**COUNCIL ACTION FORM**

**SUBJECT: URBAN REVITALIZATION TAX EXEMPTION REQUEST FOR  
PROPERTY LOCATED AT 2520 CHAMBERLAIN STREET**

A2.1

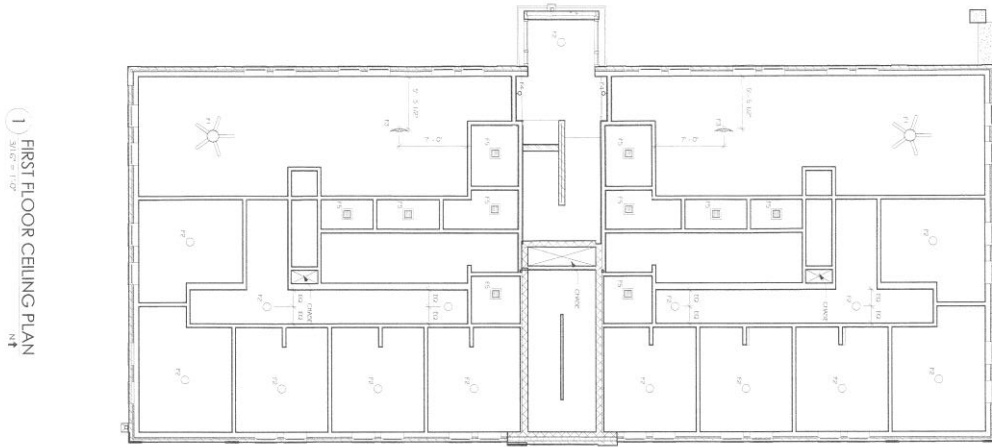
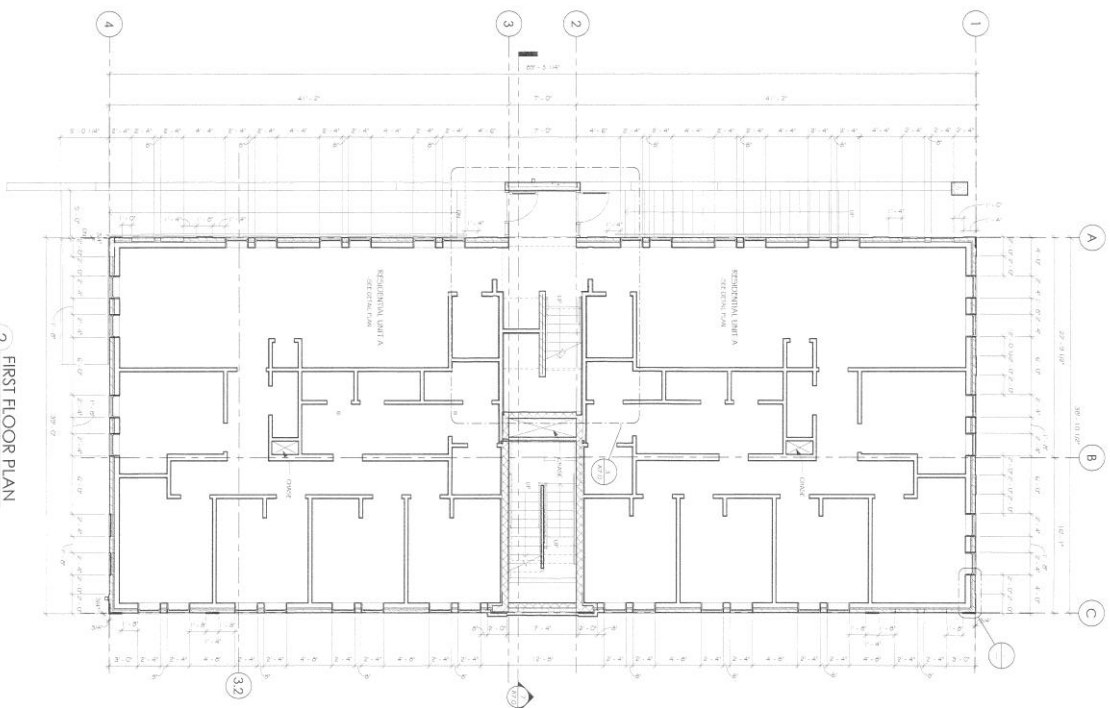
1. Listed criterion: *Limit commercial space in the same building to the ground floor.*  
Only the first floor of the proposed building will have a commercial use.
2. Listed criterion: *Provide separate entrances for commercial and residential uses.*  
The entrance to the commercial space will be completely separate from the entrances to the residential units. The residential use will be accessed from an open stairway leading from Chamberlain Street to the actual entrance door located mid-way down the west facade of the building. Also, a separate accessible access for the residential use is located by way of a ramp along the south facade of the building wrapping to the west and sharing an entrance with the front staircase.

The proposal also includes a second access stairwell on the east side of the building which has been identified by the applicant as a fire exit. This stairwell is a shared exit between the commercial and residential spaces, but is not identified as an entrance for either use.

3. Listed criterion: *Locate all residential entrances to be visible from the street and provide secure access control at each.*  
The proposed location of the residential entrances does not meet the intent of this criterion. The actual location of the entrance is along the side of the building located at the midpoint of the west facade. The staircase is located to the north and accessed off Chamberlain Street, but still poses a concern for safety without visibility to the actual entrance area. Also, the accessible ramp is located at the rear of the building and wraps to the west side of the building, not allowing for visibility from the street or the front of the building. Staff does not find that this design meets the intent of the criterion which is to have a visible entrance from the street for security purposes.

4. Listed criterion: *Prevent access from the exterior to the interior through doors that serve only as fire exits.*  
Hardware for the proposed fire exit located along the east facade will need to be installed to allow exiting but prevent access from the exterior, with a monitoring system to indicate when doors are left open.

6. Listed criterion: *Provide transparent glass windows into all stairwells.*  
The entrance stairwell is provided with glass windows in the corridor. However, the entrance is located on the west side of the building and is not visible from the street, which causes a safety concern. An exit stairwell is provided on the east side of the building abutting Chamberlain Place, but does not provide for glass into the stairwell corridor. This stairwell is a second exit point from both the commercial and residential areas, excluding the first floor residential units which are only accessible by the main entrance ramp/stair on the west side of the building. Staff does not find that this design meets the intent of the criterion which is to have visibility into all stairwells for security purposes.

- a) Revision to the entrances/exits of the building to meet criteria #2 and #3, which is to provide separate entrances between residential and commercial uses and also to locate all residential entrances to be visible from the street and provide secure access control at each,

- b) Installation of transparent glass in all stairwells as required by criterion #6,
  - c) Installation of required camera monitoring as required by criterion #7, and

**A3.1**  
 PROJECT NUMBER: 0800713  
 PROJECT NAME: ROSELAND MACKAY HORRIS ARCHITECTS P.C.  
 DRAWING TITLE: WEST ELEVATION

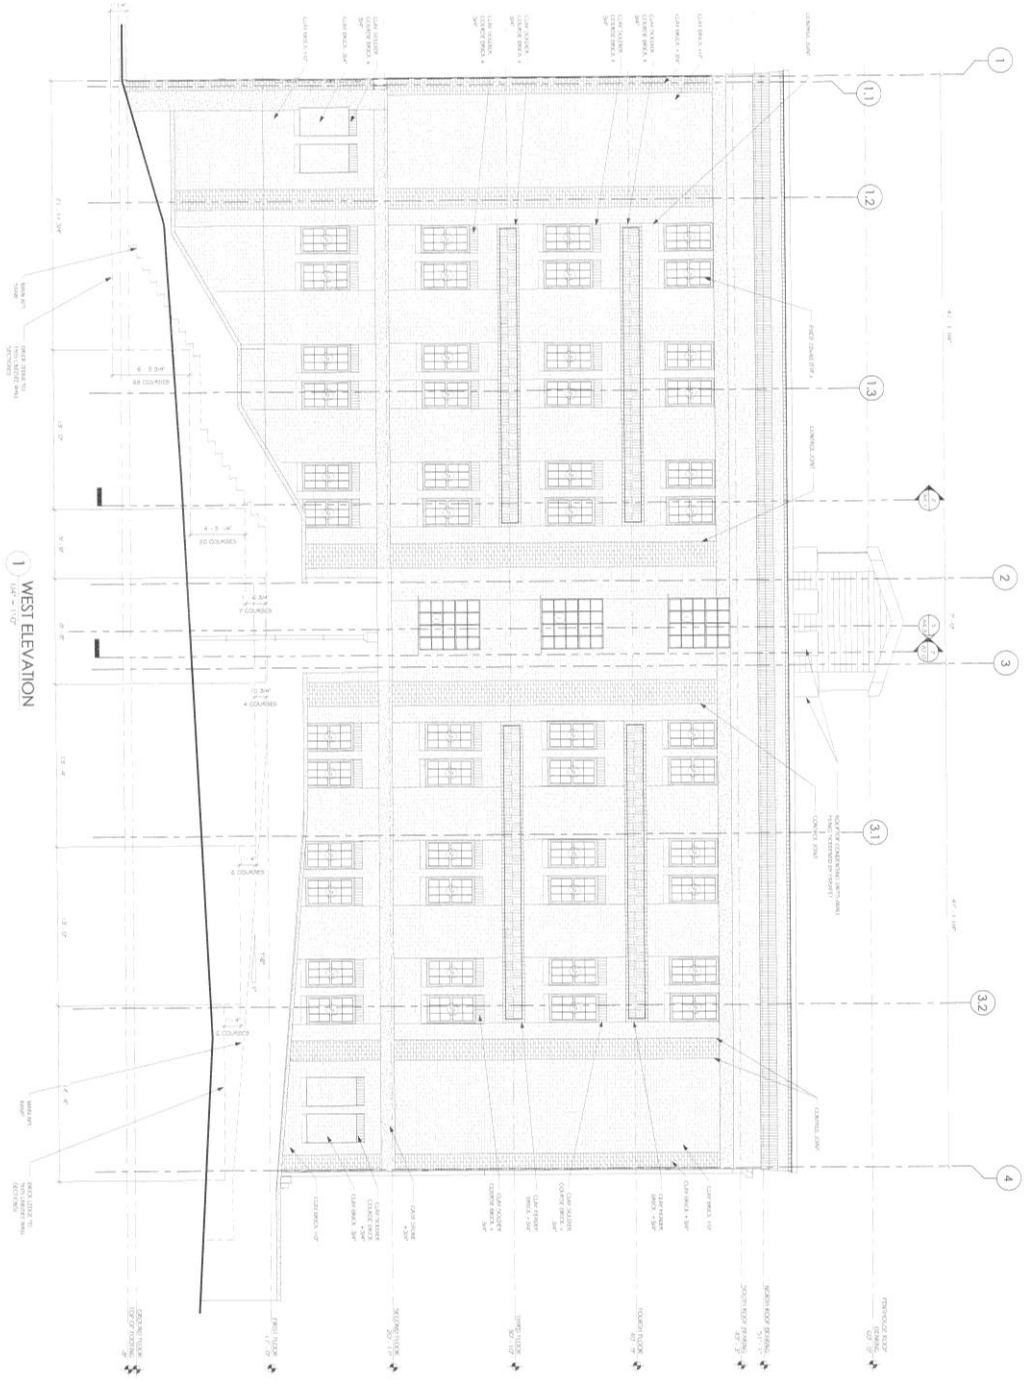
Security lighting along the south and west facades will be required to be installed to meet the intent of the code for security illumination. Staff also feels that the remote parking location for the project, if approved by City Council under a separate report, should be provided with additional lighting for security purposes.

- d) Installation of required security lighting for the building and parking areas per criterion #15.
2. If the City Council determines that the proposed project does not meet the classification of slum and blight under the Urban Revitalization Criteria, the Council can deny the request for approval of eligibility for tax abatement.
